SPECIAL PROVISIONS
FOR
NORTHERN AVENUE BRIDGE
OVER THE
ARIZONA CANAL DIVERSION CHANNEL

CONTRACT NO. FCD 87-58

To Contract Documents

ENTITLED: NORTHERN AVENUE BRIDGE OVER THE ACDC

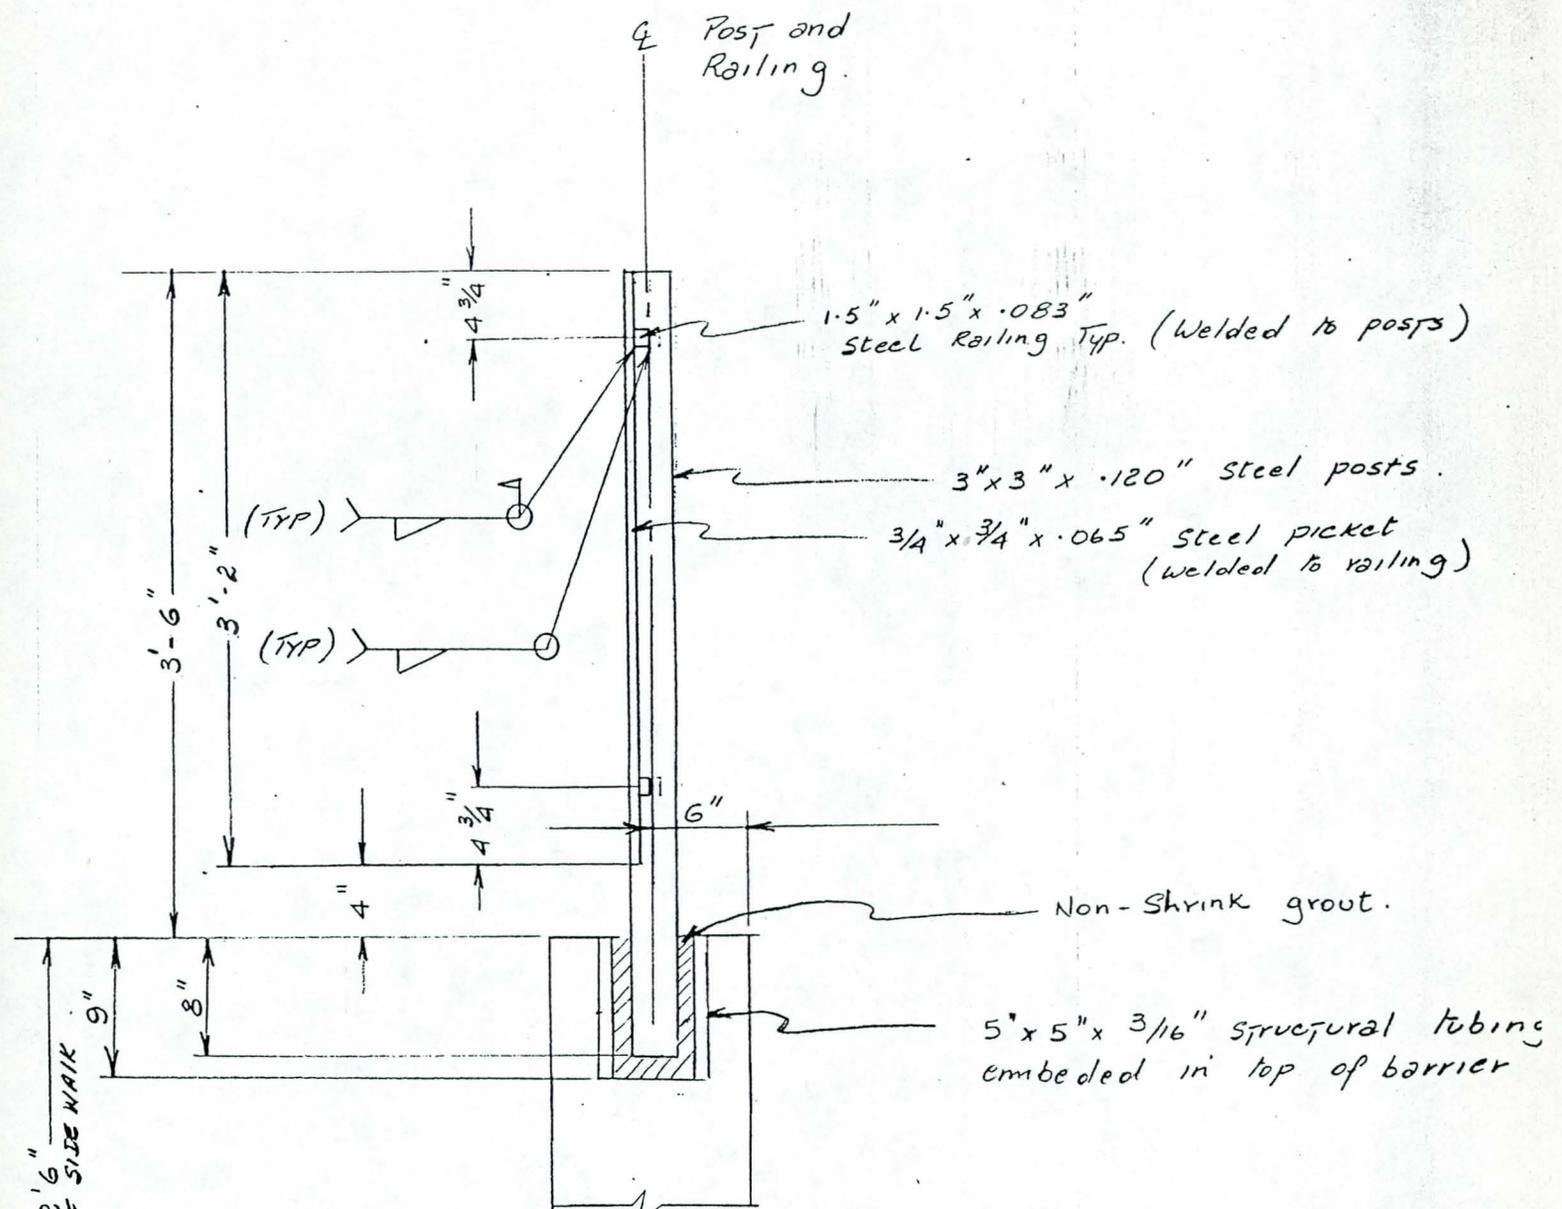
"350-8 Apartment Demolition at 12th St. 1 L.S."
4. Construction Plans sheet S-8, the handrail shown on this sheet will not be used. Substitute the picket railing shown on the attached Exhibit "A", for the handrail shown on sheet S-8. The picket railing will be paid per lineal foot, so Bidding Schedule Item 520-1 remains unaffected.
5. Construction Special Provisions, page 30 of 35, SECTION 520 - PEDESTRIAN HANDRAIL: change "as shown on the plans" to "as shown in Exhibit A of Addendum No. 1".
6. Construction Plans sheet C-4 special notes 1 and 2: both the permanent street lighting described in note 1 and the temporary street lighting described in note 2 will be paid for by others and will be installed by APS, rather than the contractor. The contractor shall coordinate the installation with APS.
